| Charlotte Historic District Commission |
| Staff Review |
| HDC 2016-191 |

| PROPERTY ADDRESS: | 1948 Park Road |

REVISED PLANS

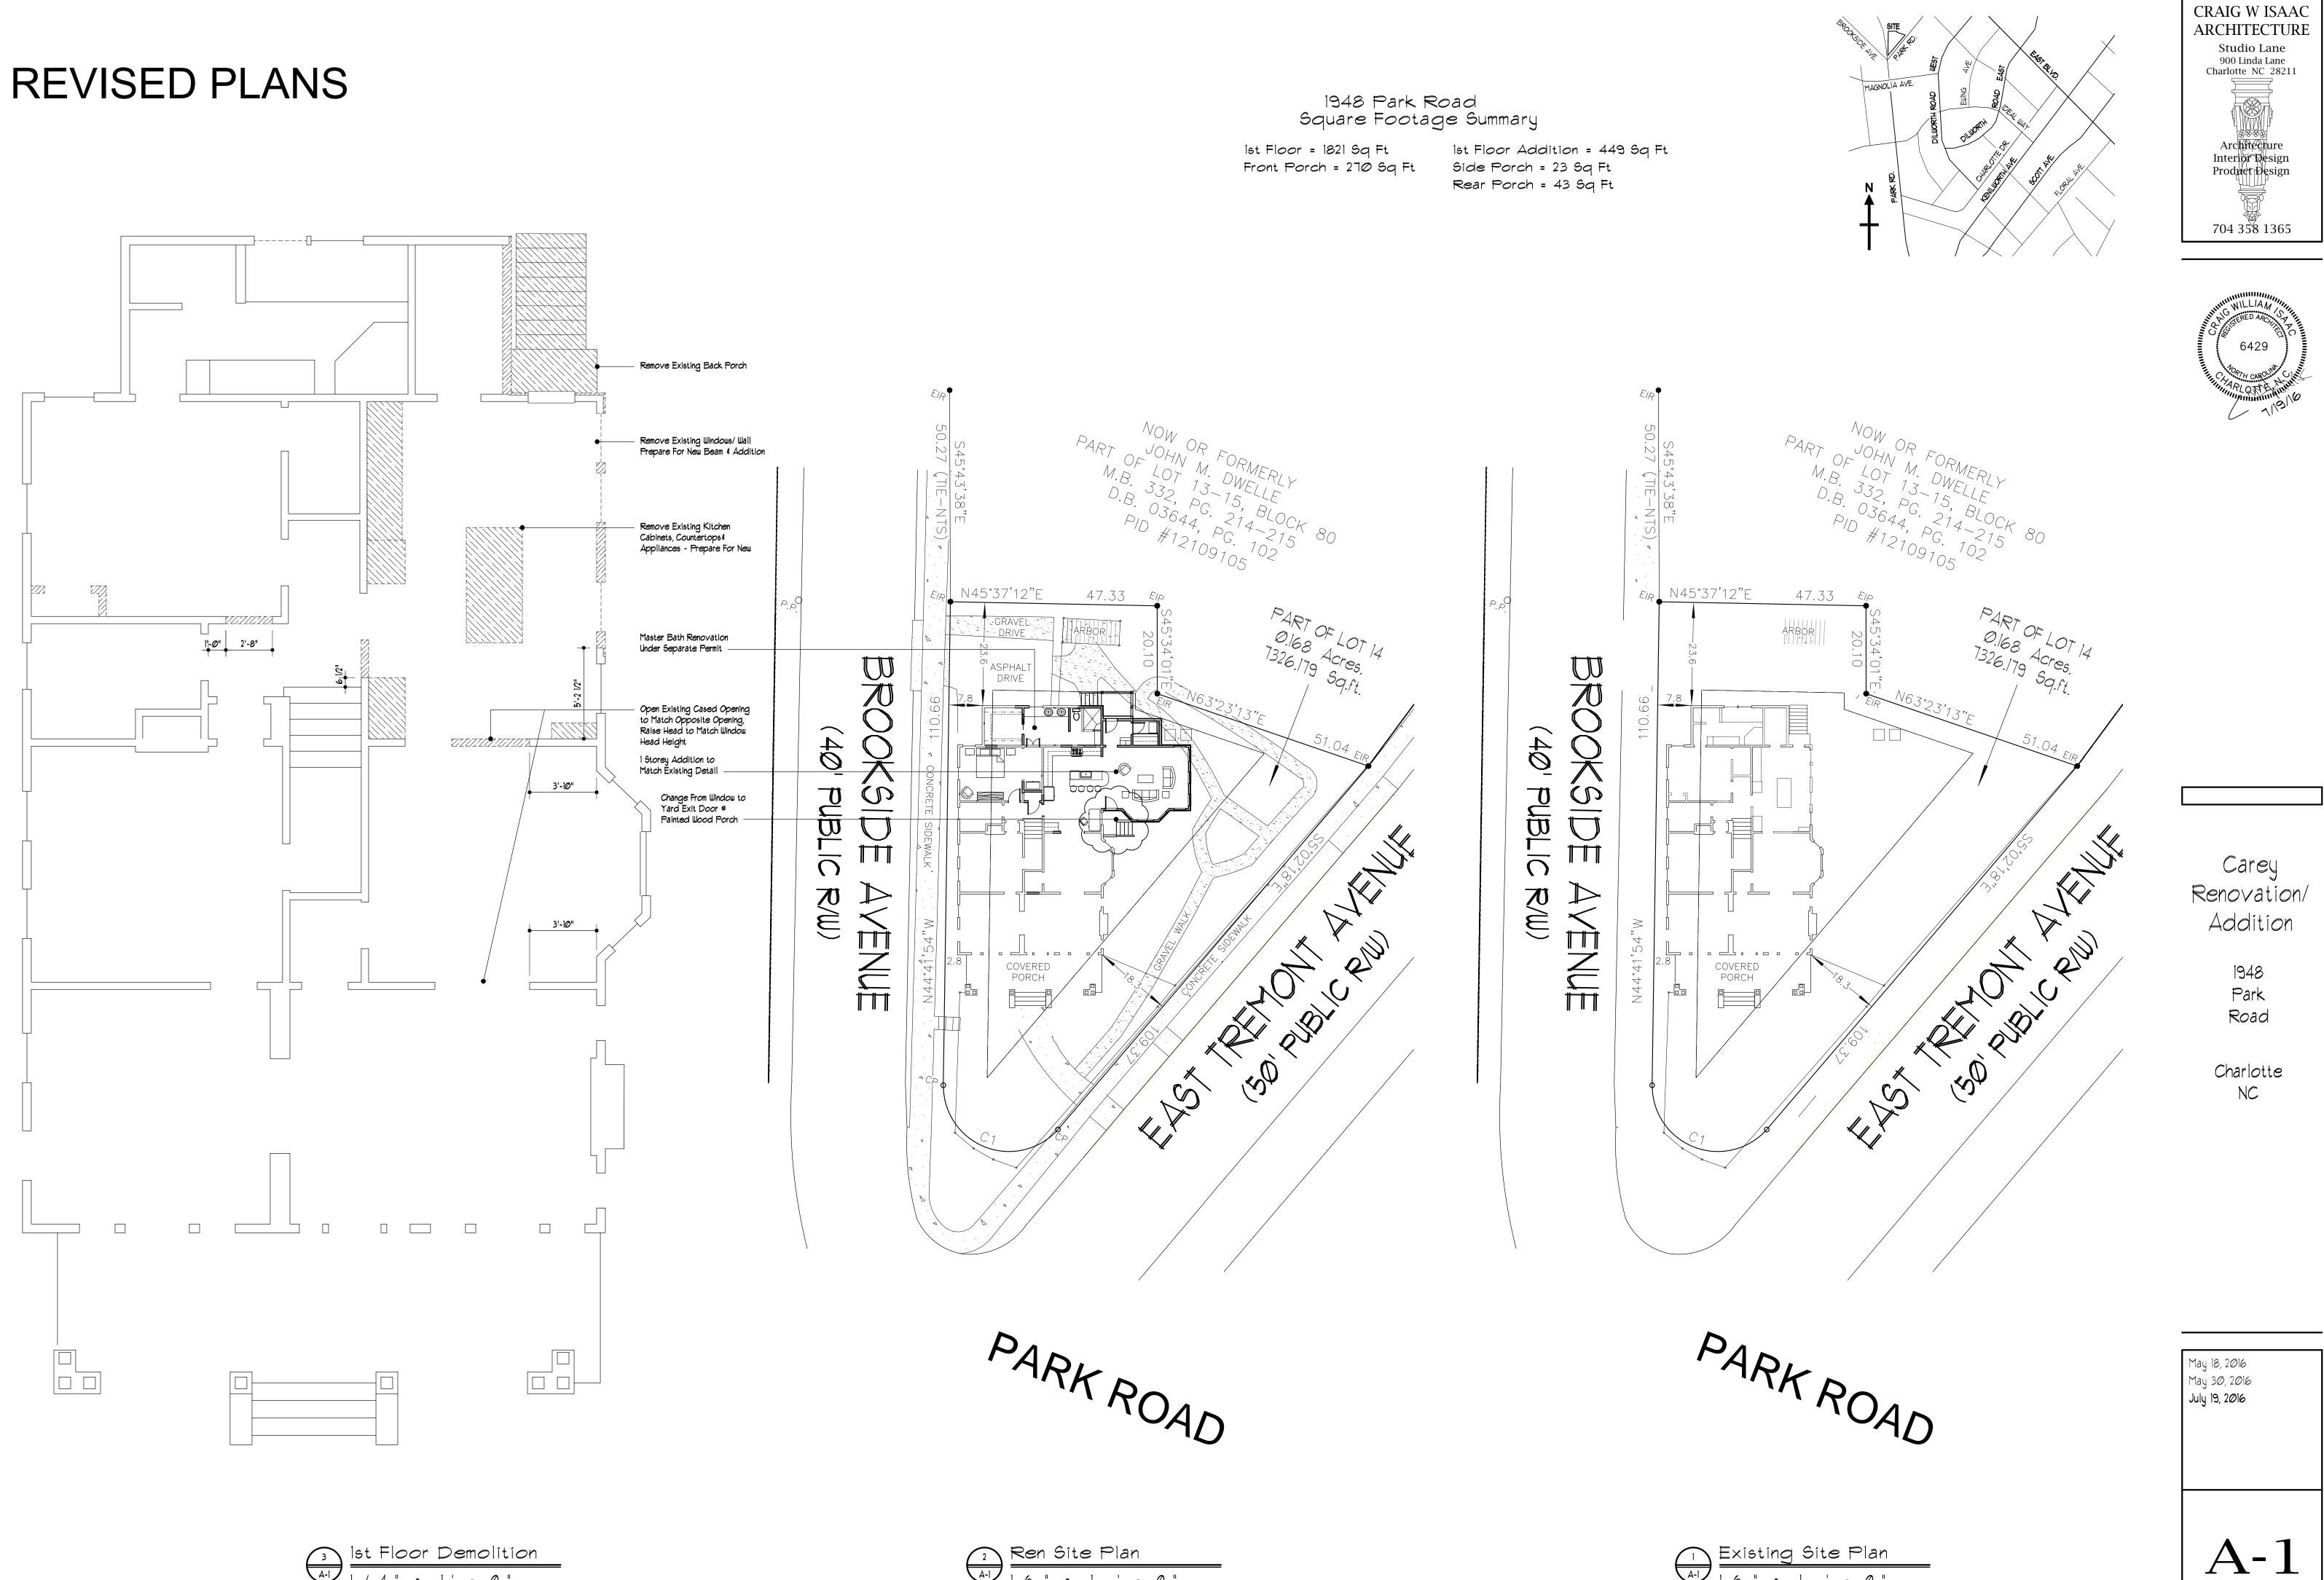
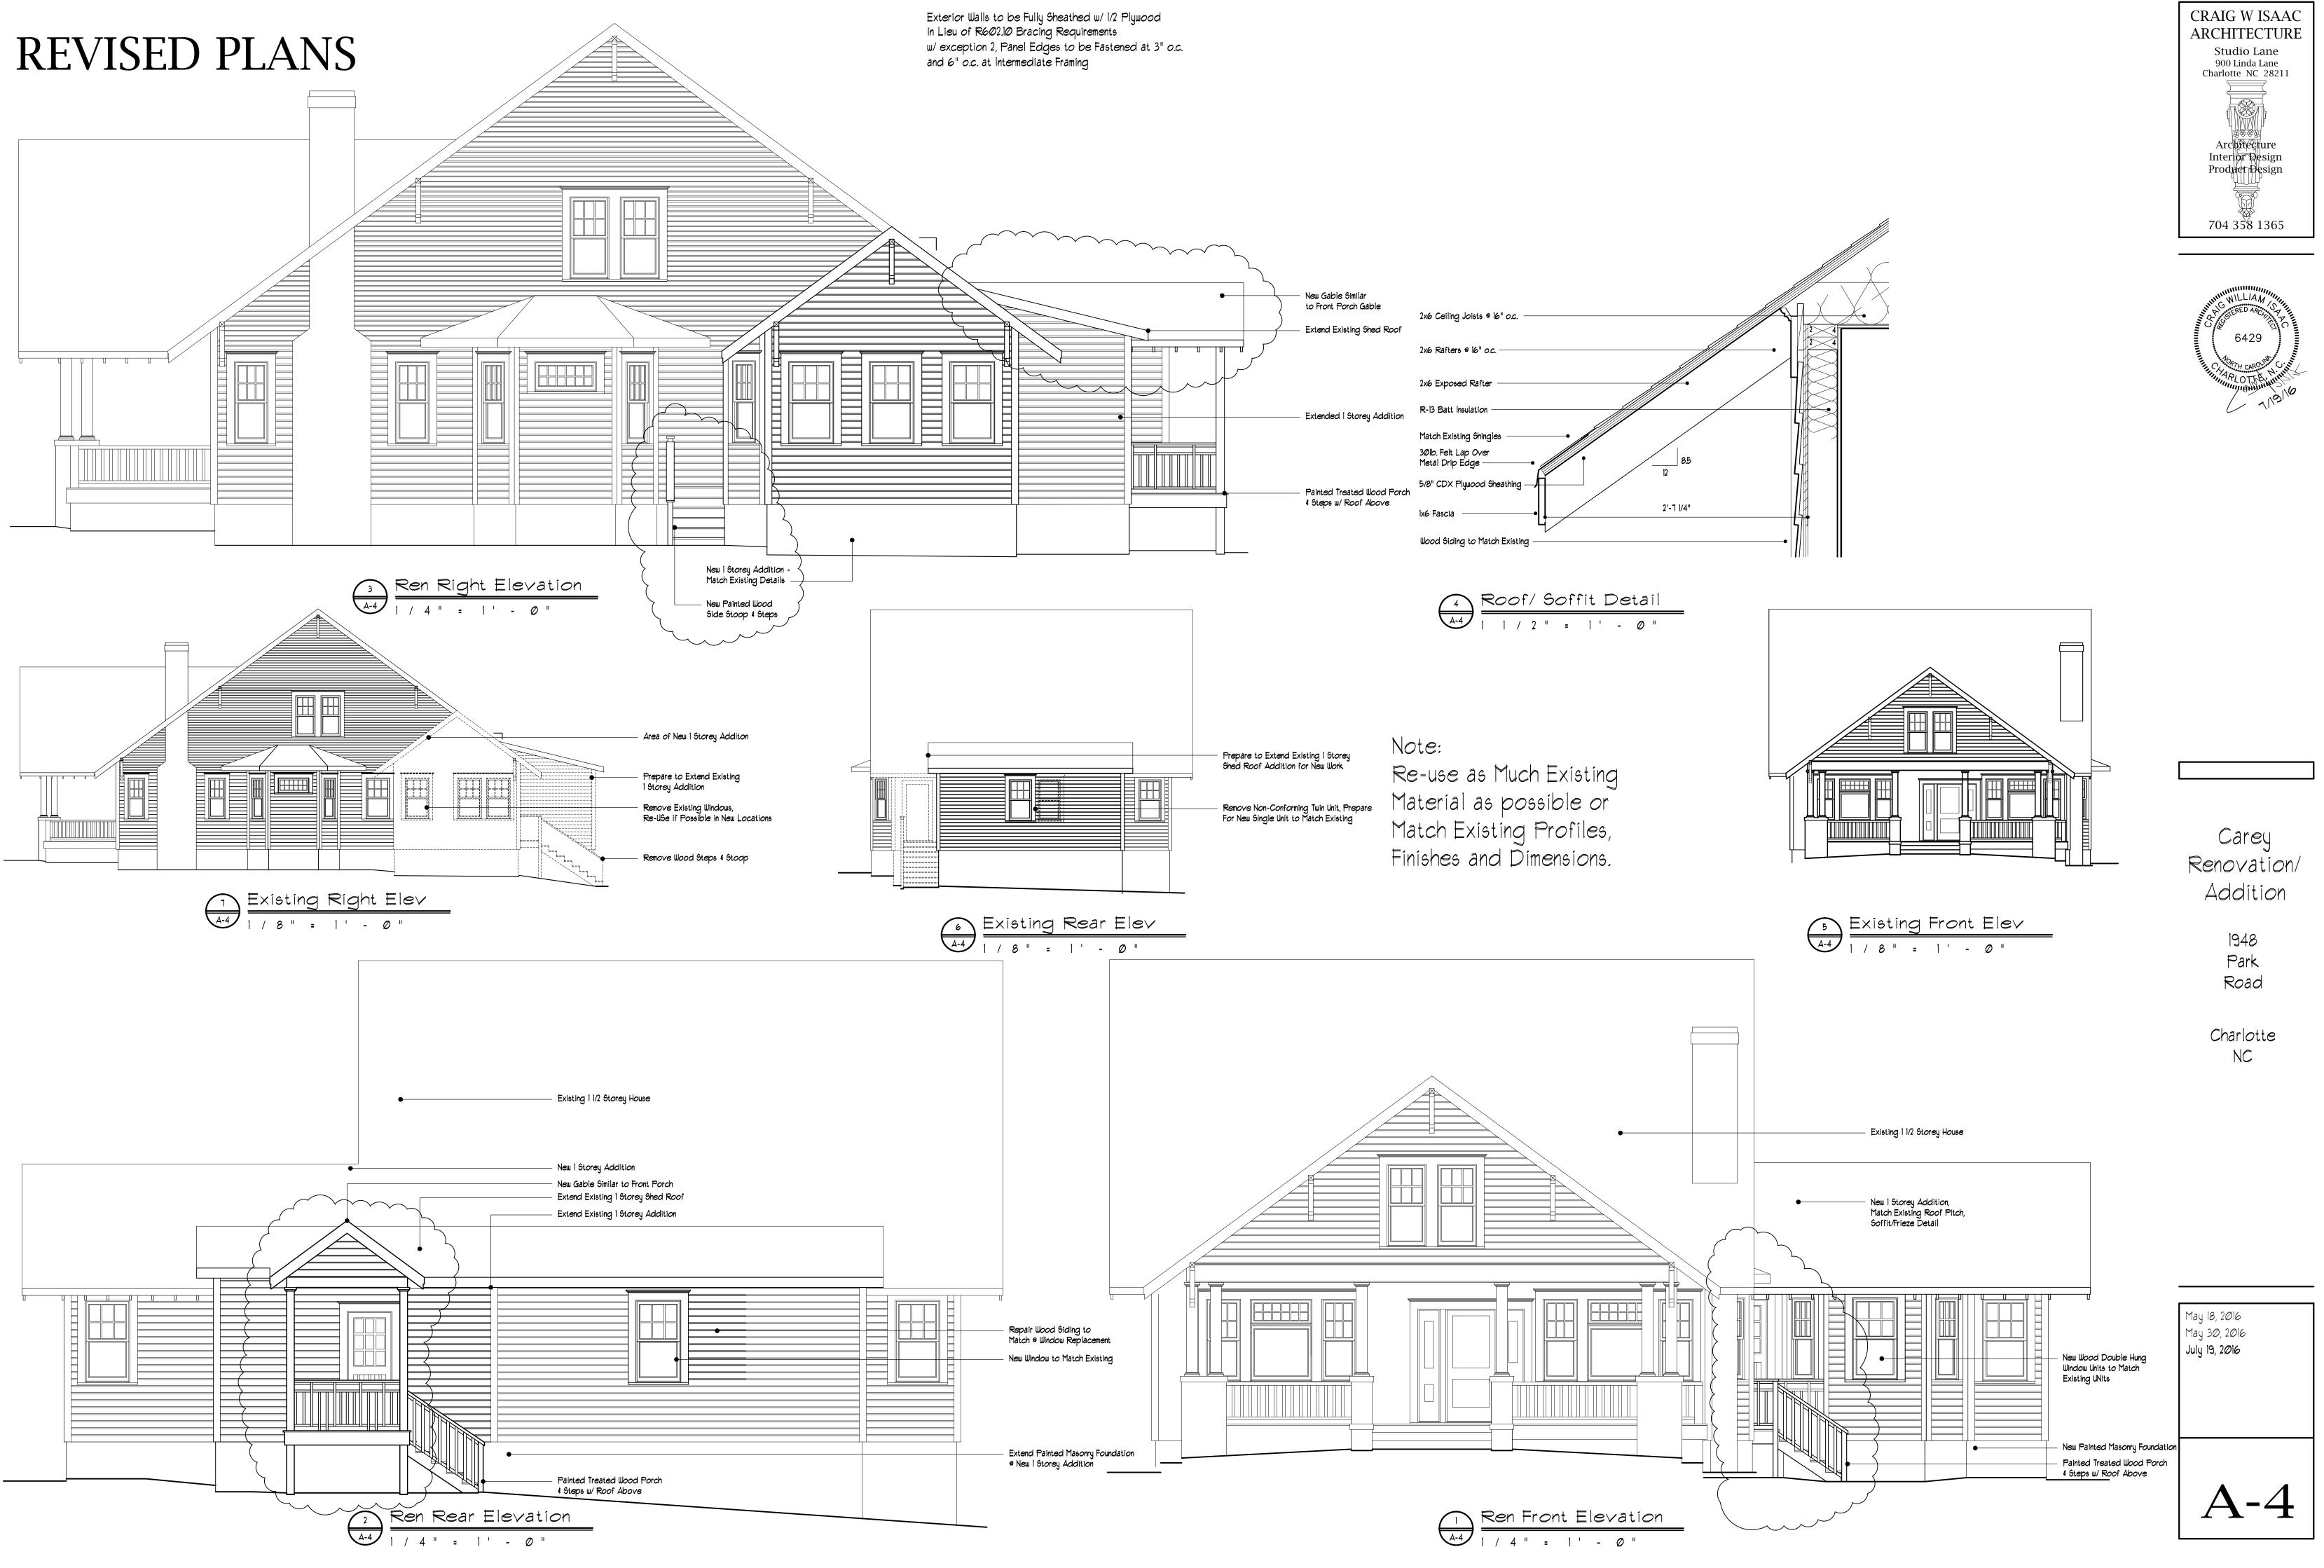
A small one story addition was approved by the HDC June 8, 2016. Details of the motion - *Disconnect the roofline at the side back door, and the stairway, it is going to be a window instead of a door and screen.*

The applicant is applying for a revision to the side addition which includes a simplified roof connection and a stair and door from the interior living space. New materials, windows and trim will match existing. The rear porch addition was approved.

<u>Staff Analysis</u> The Commission will determine if the proposal meets the guidelines for additions.
